Evaluation of 2019 Ar-41 Measurements and Analysis

Fig. 1. Background and sample spectra from 2019 measurement with correct calibration. Spectra are shifted vertically.

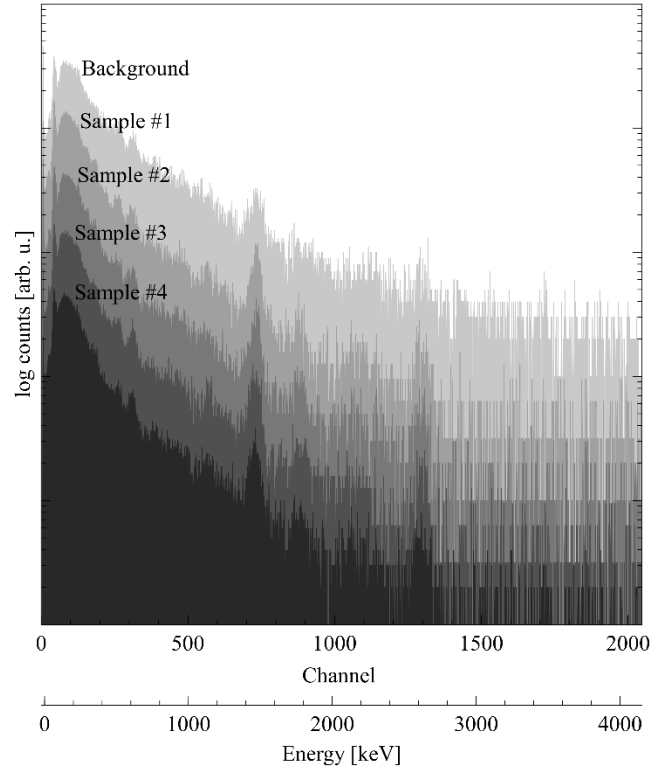
- OFI 1.2. In the 2019 and 2014 data, four additional photopeaks at 511, 610, 1460, and 2613 keV were observed in the background and sample spectra. These peaks are attributed to the naturally occurring radionuclides K-40, Tl-208, and Bi-214 which are commonly encountered in gamma ray spectra in NaI detectors [1,2]. While K-40 can be partially attributed to potassium impurities in the NaI crystal, the Tl-208 and Bi-214 peaks are members of the thorium and uranium decay series, respectively, and are likely present in the masonry and building materials in the counting lab. Although a detector shield was used, the door of the shield was partially open in order to accommodate the large Marinelli flask. Additional lead sheet was used to further reduce background contamination in the spectra. Based on the aforementioned photopeaks, however, it is likely that the amount of shielding was insufficient. Although background contamination was mostly removed through background subtraction, lower detection limits could have been achieved with additional shielding. In future measurements, the detector shield should be further extended using lead brick.

Fig. 2. Background and sample spectra as used in 2019 analysis. Spectra are shifted vertically.

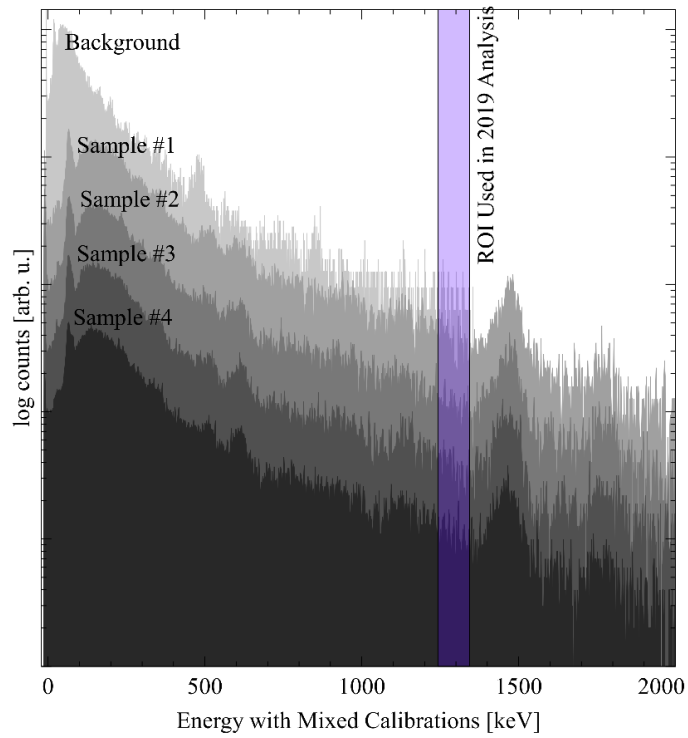
Summary: Upon inspection of the raw spectra files, it became apparent that two different energy calibrations were used in the analysis. One calibration was applied to both the Na-22 standard and background spectrum while the other was applied to the four air samples. The calibration of the Na-22 spectrum was deemed to be correct as two photopeaks, centered at 1274 keV and 511 keV, coincide with the Na-22 characteristic gamma and annihilation photon, respectively. The energy calibration applied to the four air sample spectra were also determined to be correct through comparison of spectra collected during the 2014 Ar-41 analysis. When the same calibration used with the sample spectra was applied to the background spectrum, the locations of the four aforementioned background peaks and continuum shape overlapped (see Fig. 1). However, as mentioned above, the energy calibration used for the Na-22 spectrum was applied to the background spectrum. The situation is represented in Fig. 2.

A shaded rectangle indicates the region of interest (ROI) used to quantify the Ar-41 activity. No photopeak can be visually identified in any of the spectra. Therefore, the ROI gross counts in each of the sample spectra primarily reflect the continuum background. If a photopeak was present, the chosen ROI would be slightly narrower than the FWHM of the photopeak, which would result in underestimation of photopeak area. Use of 50 channels is called for in the counting procedure. However, in the years when that procedure was developed, the detector and multi-channel analyzer (MCA) was configured to have an approximately 10 keV/ch bin width. In 2014 and 2019, 2 keV/ch were used.

In the quantification procedure, the gross background counts were subtracted from the gross sample counts. Due to the use of the incorrect energy calibration in the background spectrum, the gross background counts, having been measured at a higher energy (around 4000 keV), were significantly lower than the continuum background of the sample spectra in the Ar-41 region. Thus, the quantity reported as the net Ar-41 counts was essentially a difference in gross counts within two different energy ranges of the same background, a physically meaningless quantity. This explains why the reported Ar-41 concentrations at each sampling location were all similar in value (3.11×10^{-6} - 3.27×10^{-6} $\mu\text{Ci/mL}$) and an order of magnitude larger than expected based on the SAR and results from previous years.

- CA 2.1. SOP 654 shall be revised to establish an ROI selection procedure based on detector type, HV, gain and MCA settings.
- CA 2.2. SOP 654 shall be revised to establish detailed procedures that ensure a common and correct energy calibration is applied to the spectra. It will also provide additional guidelines for selecting HV and gain settings.

Fig. 3. Comparison of spectra from Na-22 standard and background. Note that the counting times were the same (1800 s).

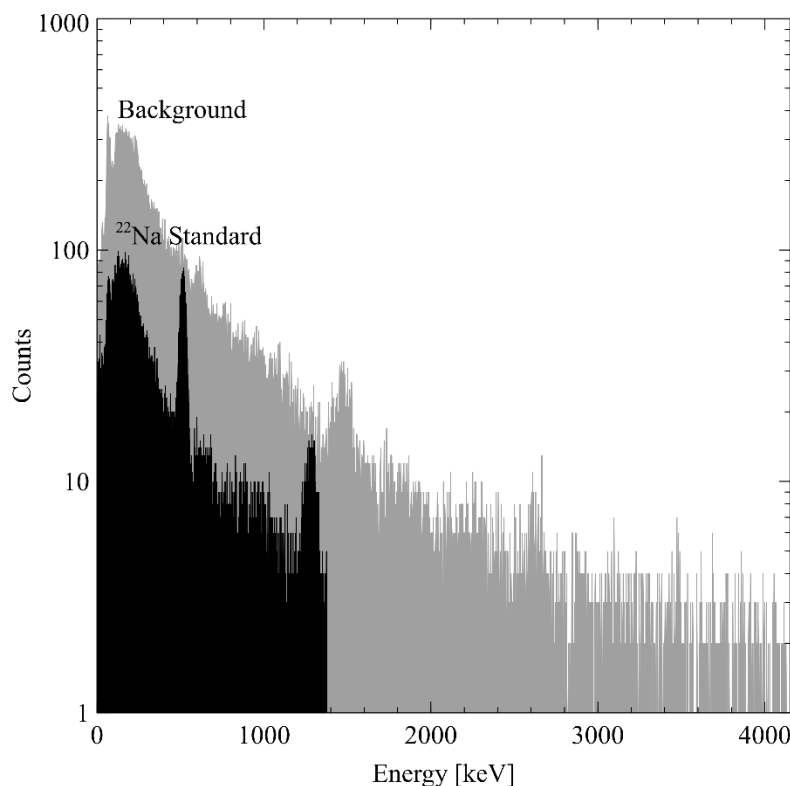
As the Na-22 spectrum had a different energy calibration, it is possible that the high voltage (HV) or gain settings were changed for that acquisition. Indeed, the continuum background in the Na-22 spectrum was significantly lower than the background spectrum (Fig. 3). It is therefore doubtful that a simple method of gross background count subtraction would result in an accurate efficiency determination.
